Subject: Application Incomplete (SUB15-00632)

The application you submitted on November 18, 2015, for the proposal identified above, has been reviewed for completeness. As of today, we have determined that your application is not complete. Please submit the following additional information:

Figure 1 - UF Field Notes: Trees incorrectly surveyed.

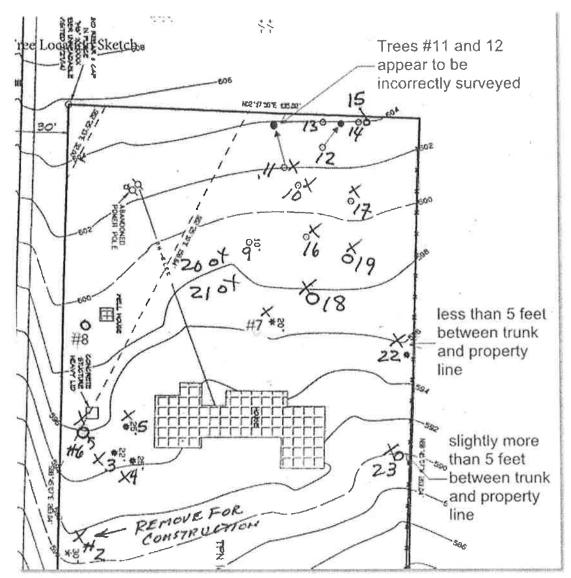
- 2. Survey: Trees #11 and 12 appear to be incorrectly surveyed, see Figure 1 below. Tree #7 is a pine approximately 25' west of the center of the house and the tree near the well house is #8.
